Morlais Project

Metocean and Physical Processes ES Supplementary Note

Applicant: Menter Môn Morlais Limited
Document Reference: PB5034-RHD-ZZ-XX-NT-Z-1007
Author: RHDHV

Date:
25/03/2020

Figure 2.1. Peak suspended sediment transport (m^2/s) x is a modelled location in the original paper (Robins et al., 2014) from which this figure is extracted and not of relevance to this discussion

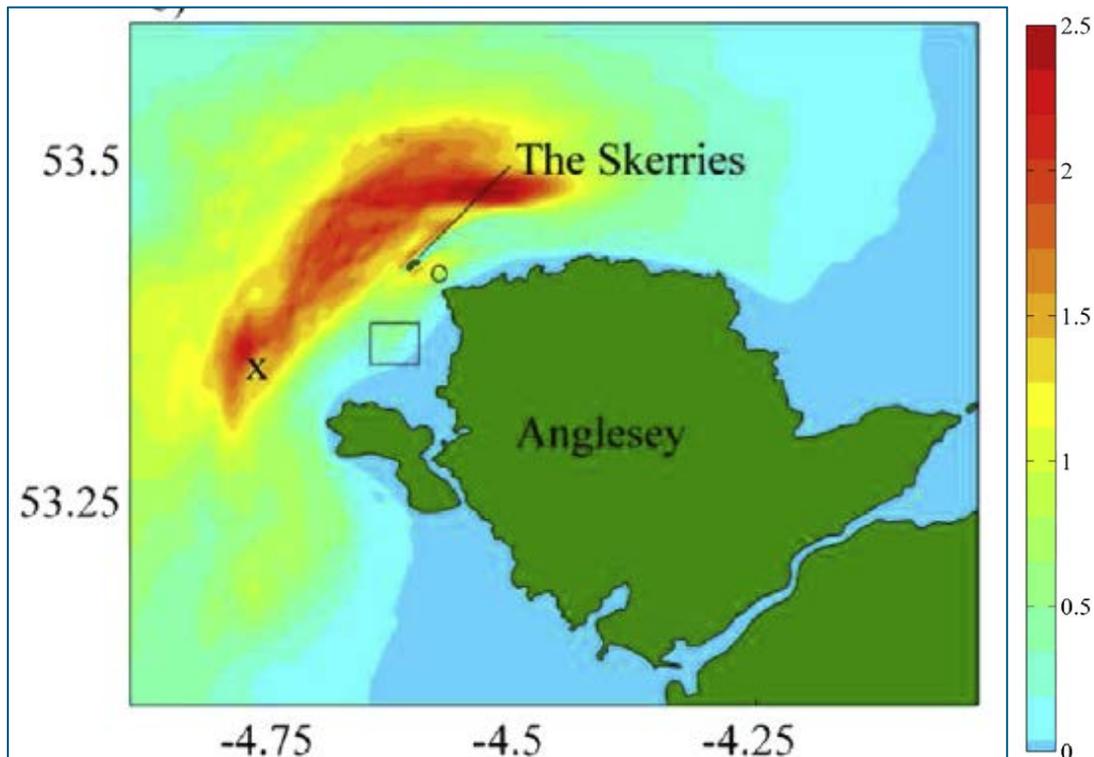
Clarity is required on the location and magnitude of the Anglesey Turbidity Maximum

Ellis et al. (2008) and Robins et al. (2014) showed that satellite visible band, *in-situ* optical data and measured suspended sediment concentrations reveal significant features in the distribution of surface suspended sediment in the Irish Sea. Areas of consistently higher concentration than the average suspended sediment concentration are observed in geographically fixed locations. One of these turbidity maxima lies to the north and west of Anglesey. The surface concentrations in excess of 10 mg/l compare to background levels in the surrounding water of 3-4 mg/l. Hence, the term 'turbidity maximum' to describe the feature is a misnomer, because although it is a maximum in the sense that it is measurably greater than the surrounding areas, the maximum concentrations remain very small. A figure showing the modelled location and magnitude of the

so-called ‘Anglesey Turbidity Maximum’ is shown in Figure 2.1 in terms of peak suspended sediment transport (Robins et al., 2014). This figure can also be used to support the baseline suspended sediment concentration assessment as the data defining the Anglesey Turbidity Maximum extends across the MDZ.

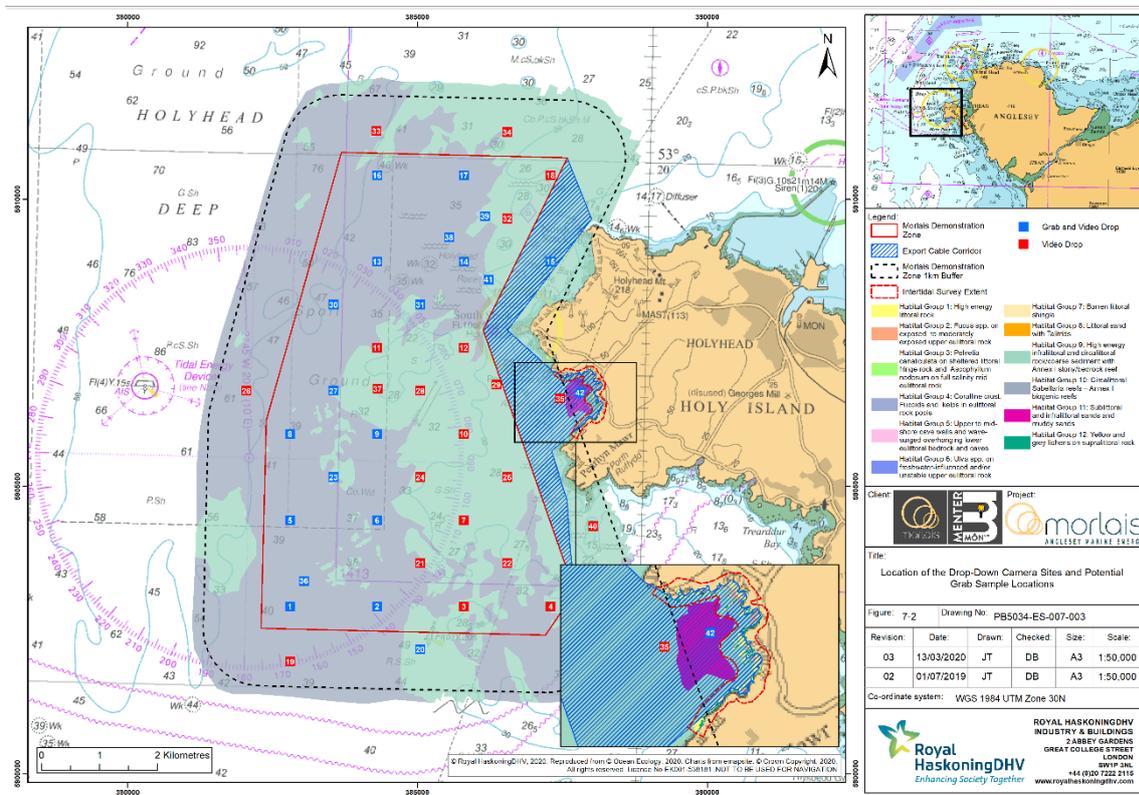
The applicant states there is ‘High’ confidence in the subtidal grab sample survey. NRW is concerned that only five samples were obtained and then can only find information on a further four through the ES. For a development of this size NRW would expect more coverage. Figure 7-2 shows 18 grab sites; clarification is required on why these aren’t

included in the ES. Three of the grab samples discussed are labelled as video drop sites (15, 20, 42); clarification is sought on what this means

The data presented regarding sea bed habitat type seem different to those presented in Appendix XI: Subtidal EUNIS Biotope Summary so clarification is also sought on this. In Figure 7-2 the grab sample retrieved from station 41 looks to be within the sand wave and is shown as 'surface mobile sands'. However, the analysis states it is 73% gravel and 27% sand. Clarification is sought on this

The sea bed sediment sampling methods used to support the ES were part of a targeted sampling plan, with the aim of ground truthing the acoustic data. The use of sediment grabs was planned at those locations where acoustic data indicated sediment was likely to be present.

There is high confidence in the samples that were collected and their analysis for particle size. Forty-two ground-truthing stations were targeted and sampled across the MDZ, buffer area and proposed cable corridors. At every ground-truthing station, a drop-down camera was deployed to collect sea bed imagery. Grab samples were initially considered at 18 stations (based on backscatter interpretation) to collect sediment samples for particle size distribution and for in-situ faunal analysis to inform subsequent biotope mapping. On review of the drop-down camera footage, it was deemed that only five of these 18 stations were suitable for grab sampling due to the hard substrate present, resulting in the acquisition of just four grab samples. The grab sites shown in Figure 7-2 are the proposed sites, not the actual sites, which number only four where sediment could be recovered. The five samples indicated in Table 7.9 is a typing error, it should be four. Grab samples 15, 20 and 42, have been wrongly labelled in Figure 7-2. They should be colour coded blue (grab and video drop), not red (video drop) and this has been changed on the figure.

The underlying sea bed habitat type data was extracted from an existing subtidal habitat mapping web site (EMODnet) and does not relate to the new geophysical and sea bed sediment data collected for this assessment. Therefore, there is the potential for a mis-match between the existing and new data including station 41. Figure 7-2 has been updated to include the EUNIS and Annex I habitat mapping based on the information collected during the benthic survey (supported by the geophysical survey). The figure is provided below.

Figure 4.1. UKCP18 model grid used to derive sea-level rise projections for Holyhead

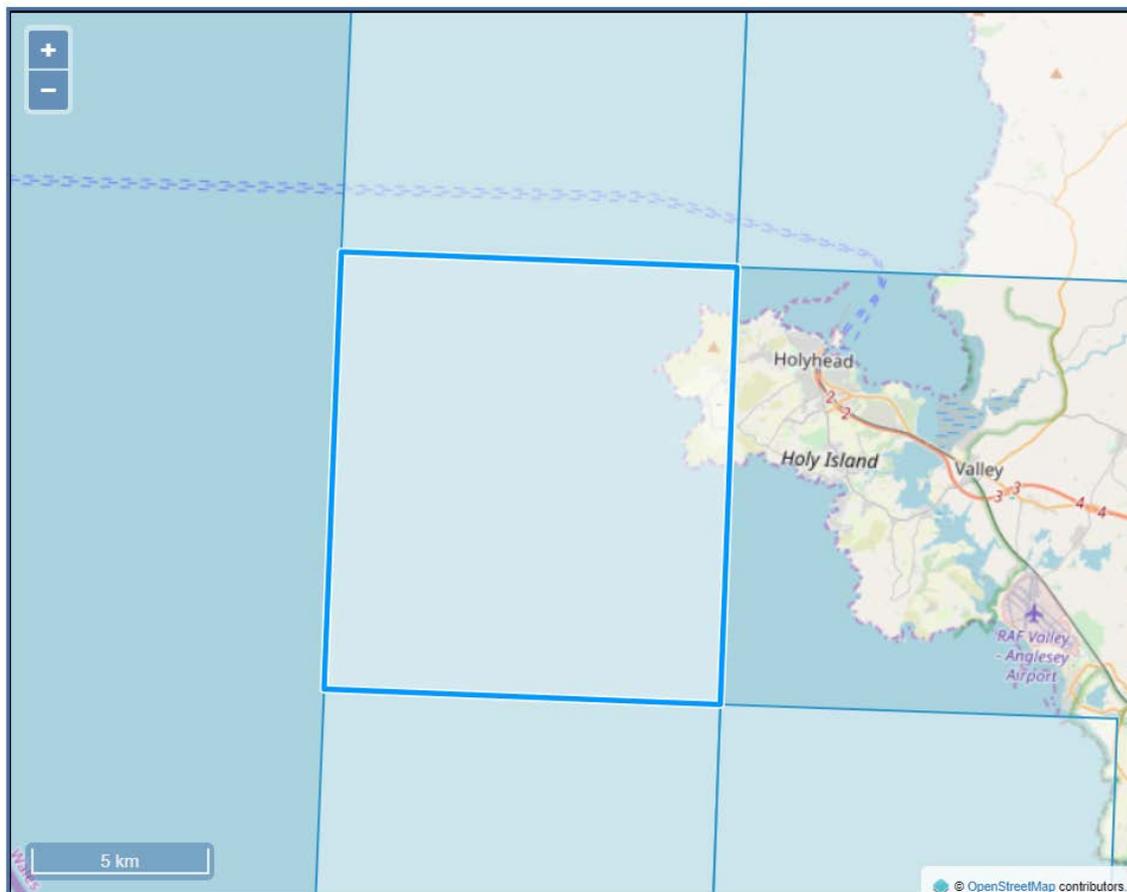
It is unclear how climate change and waves have been accounted for within the ES. Include more discussion of in the ES chapter. NRW would like clarification on the location of the sea level rise indication and believe it would not be too onerous to extrapolate to the entire project lifetime. It is noted that no extreme H++ scenario is characterised. It is also unclear how climate change scenarios have been used within the ES to discuss impacts.

UKCP18 data has been used in the projection of sea-level rise to 2050. Additional data is included below to extend this period to the anticipated project life time of 37 years (2061). An assumption is made that operation will begin in 2024.

The UK Climate Projections (UKCP18) user interface for the model grid cell that covers Holyhead is shown in Figure 4.1. UKCP18 relative sea-level rise estimates use 1990 as their starting year and are based on the IPCC 5th Assessment Report. They are available for low (RCP2.6), medium (RCP4.5) and high (RCP8.5) emissions scenarios and presented by UKCP18 as central estimates of change (50% confidence level, 50%ile) in each scenario with an upper 95% confidence level (95%ile) and a lower 5% confidence level (5%ile).

Figure 4.3. WFD water bodies and shellfish directive waters

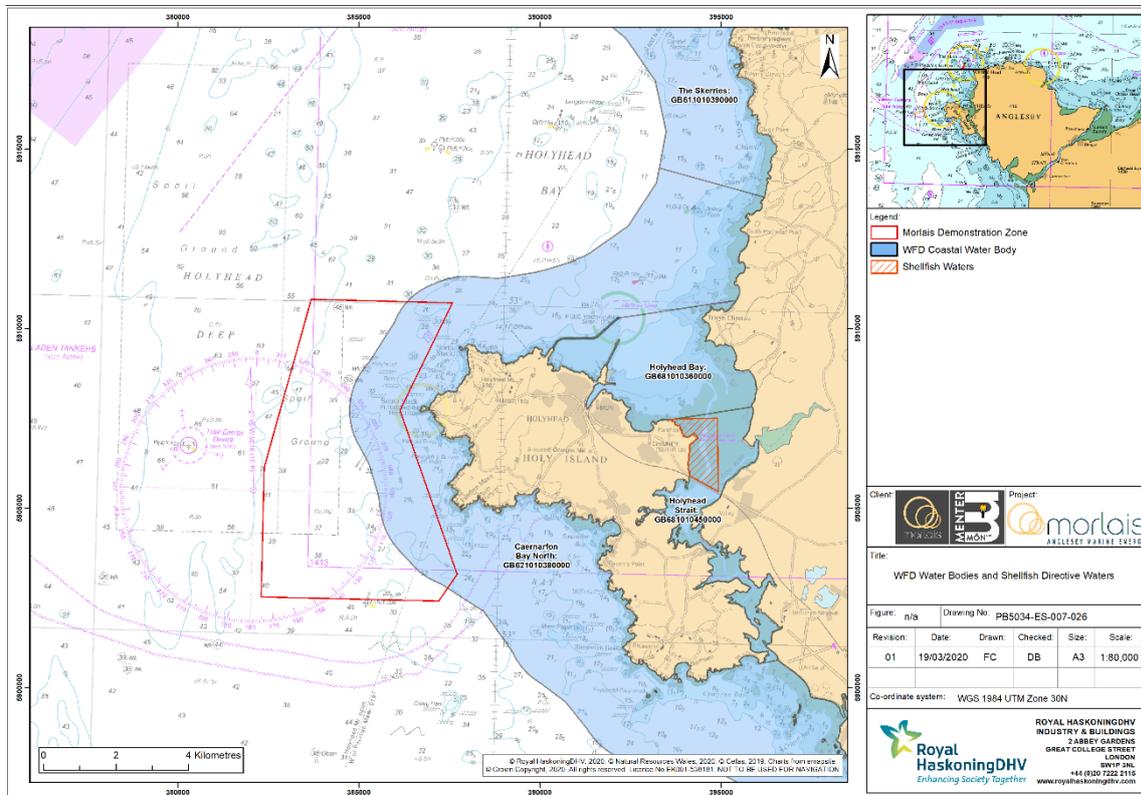
Water quality impacts to the east of Holy Island have not been fully considered. The Beddmanarch Bay Shellfish Water (SFW) is a protected area under the Water Framework Directive (WFD) and is within 2km of a development site, but is not included in the ES Volume II, Figure 8-1, nor is it mentioned in Volume I, Chapter 17 of the ES. Holyhead Strait WFD waterbody may be impacted by water quality issues due to works on Holy Island but is not mentioned in the ES Volume I, Chapter 8. Please note that our wider comments on the Water Framework Directive assessment are presented elsewhere in this Annex.

Beddmanarch Bay is east of Holy Island which is many kilometres away in terms of a water connection (Figure 4.3). So, it was excluded based on distance. The numerical modelling is likely to show that there will be no change to physical processes at this location due to the development.
